Countries:	CANADA, UNITED STATES	Document ID:	IK1600227
Availability:	ISIS, IsSIR	Revision:	6
Major System:	CAB / SLEEPER / HOOD	Created:	7/13/2017
Current Language:	English	Last Modified:	9/19/2018
Other Languages:	NONE	Author:	Steven Bautz
Viewed:	1339

Title: Loose, Missing, or Damaged Glass in the LT Hood Mounted Mirror

Applies To: LT

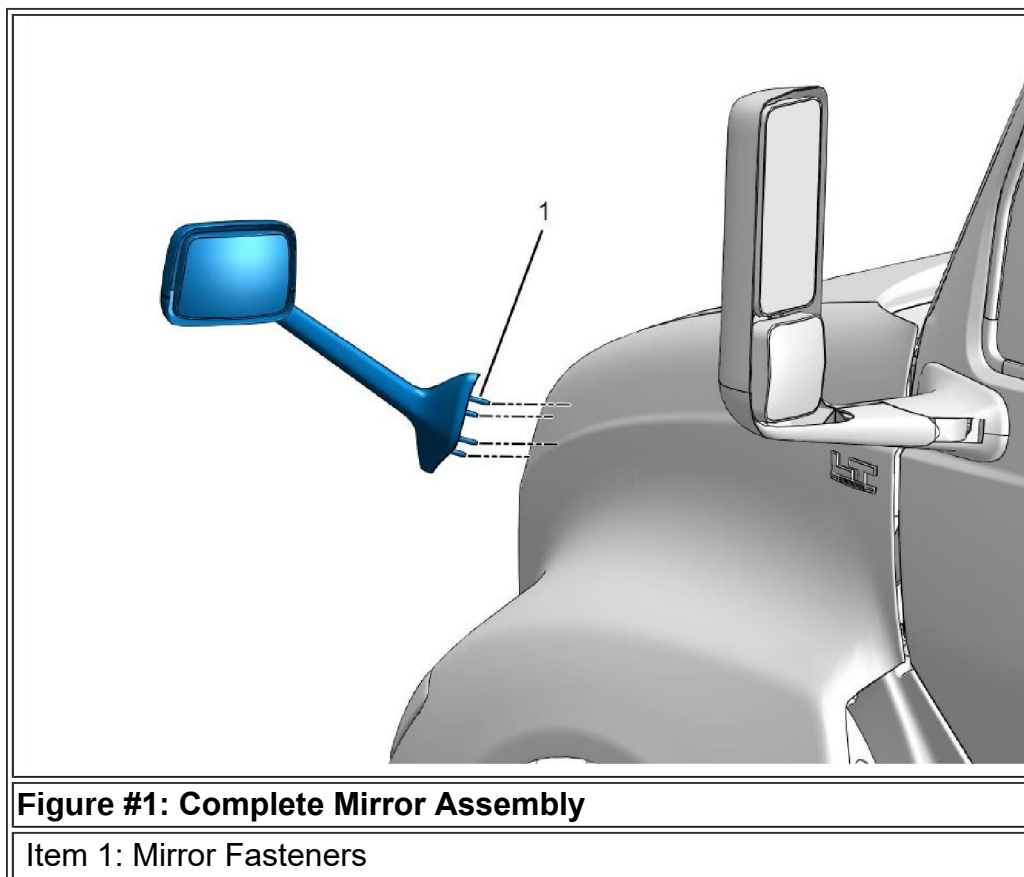
This document will guide the user through the inspection and replacement of the hood mounted mirror assembly. (Glass ONLY replacement is not recommended.) As of November 2017, the design for the mirror glass attachment has changed to be permanently epoxied into the housing. Servicing the glass only is no longer an option.

Note: All C93 or C94 replacement mirror assemblies should have a Green Dot added to the P/N label and/or on the mirror packaging. The green dot indicates the mirror assembly has had epoxy added to the internal clips so the glass panel cannot be removed or fall out of the housing assembly. If the glass can be removed by rotating the internal lever behind the glass panel; return the mirror assembly back to Navistar for an assembly that has been epoxied.

Inspect the condition of the mirror assembly. If the mirror is either loose or missing, the complete mirror assembly (Head & Arm) will need to be replaced.

Note: The replacement mirror assemblies have the glass epoxied in place. Going forward all LT hood mirror glass panels will not be serviceable separately. The entire mirror assembly (Head & Arm) will need to be replaced to avoid the glass from falling out during vehicle operation.
